Proposal #35: 8190-00-72, WISC 2022033
Bloomer - Cornell
North Jct STH 40 to CTH E
STH 64
Chippewa County

8620-00-73, WISC 2022036
Bloomer - Bruce
13th Ave to East Jct STH 64
STH 40
Chippewa County

This is Addendum No. 01, which provides for the following:

ADDENDUM NO. 01
8190-00-72 & 8620-00-73
April 4, 2022

Addendum No. 01
 ID 8620-00-73
 Revised Sheet 45
 April 4, 2022

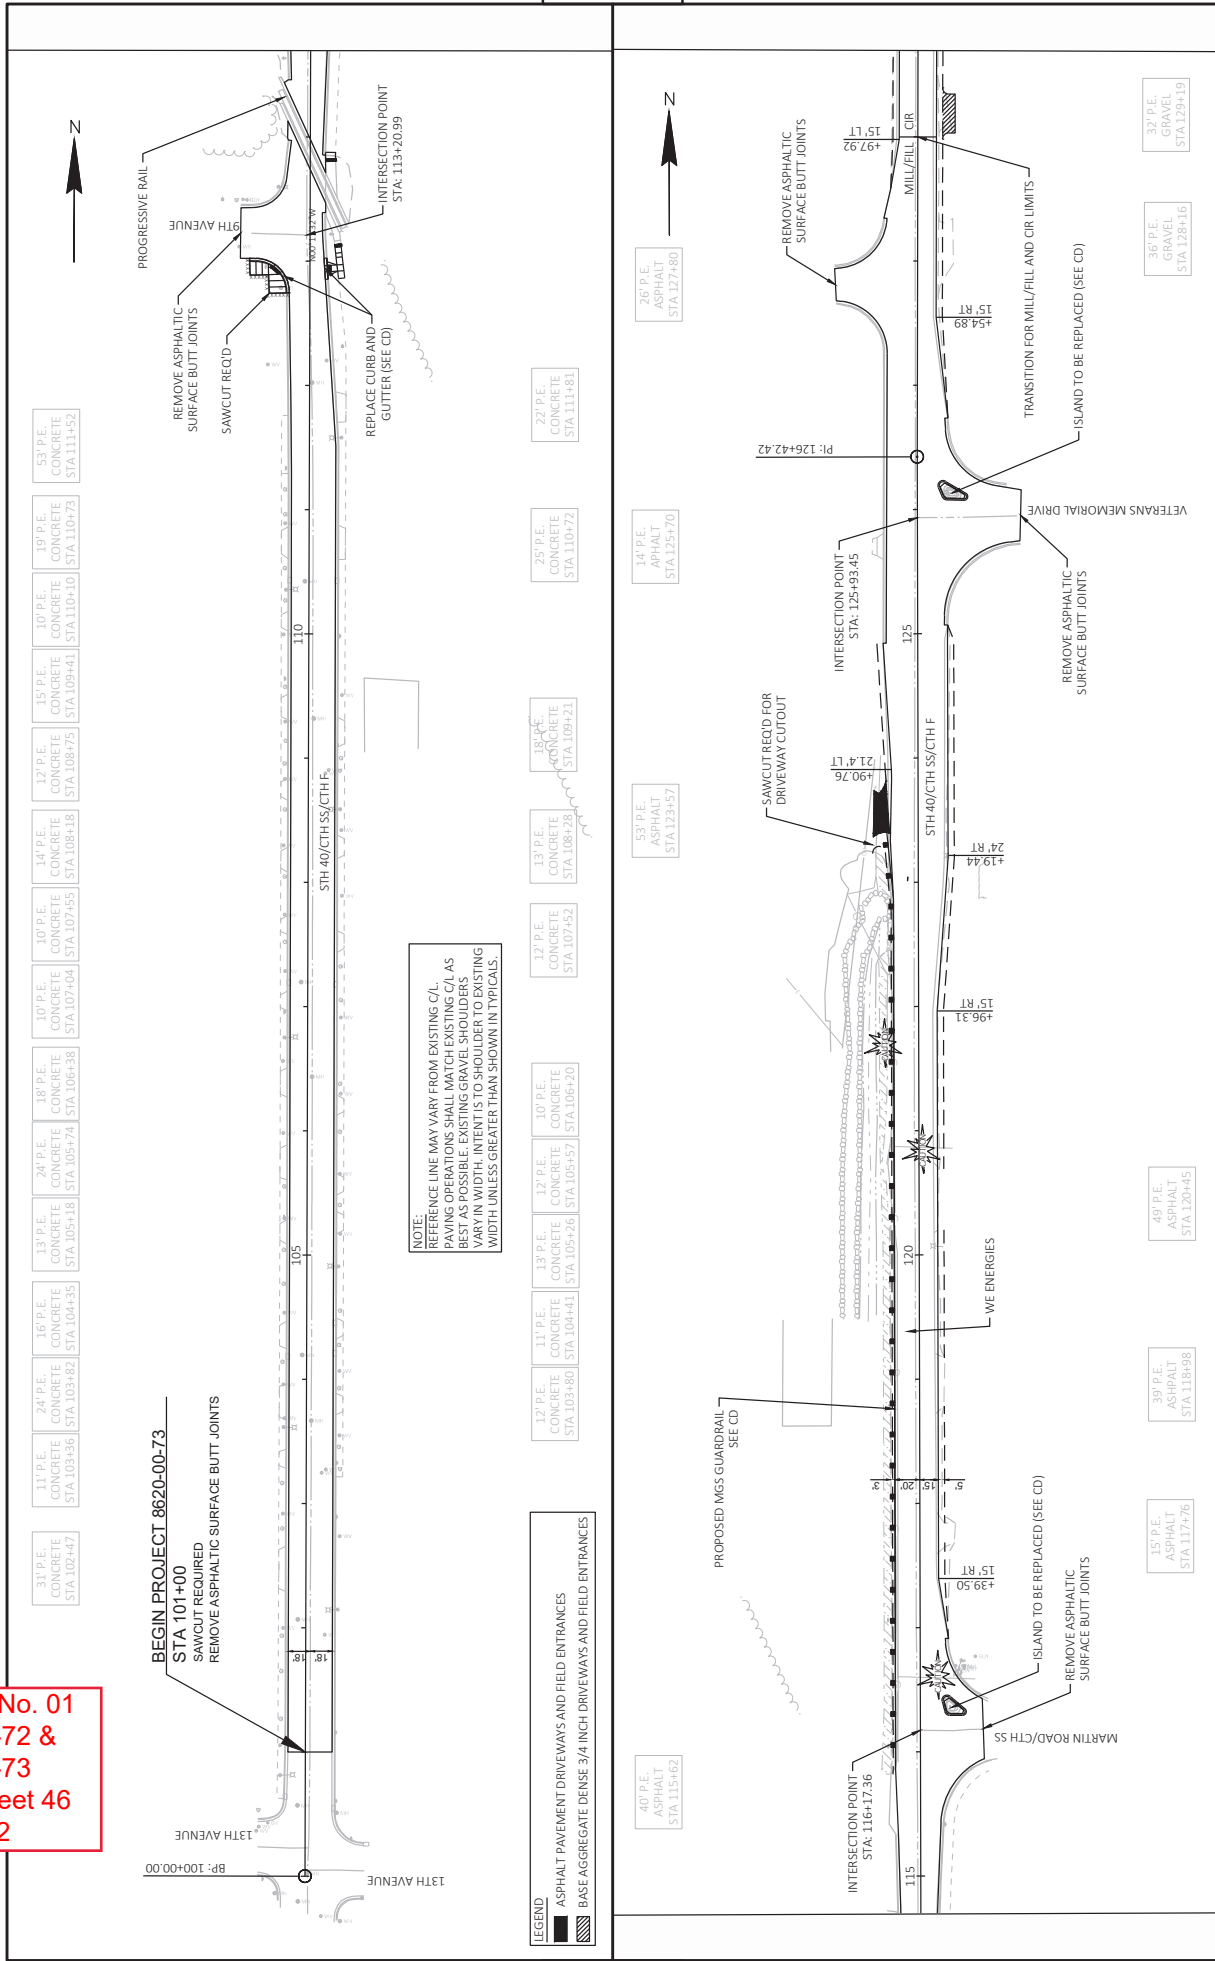
Revised Plan Sheets	
Plan Sheet	Plan Sheet Title (brief description of changes to sheet)
14	Construction Details (Guardrail layout and sawcut locations revised)
43	Miscellaneous Quantities (Beamguard Items quantities revised)
45	Miscellaneous Quantities (Sawing Asphalt quantities revised)
46	Plan (Guardrail layout revised)
65 - 71	Cross Sections (Guardrail location and grading revised)

SAWING ASPHALT
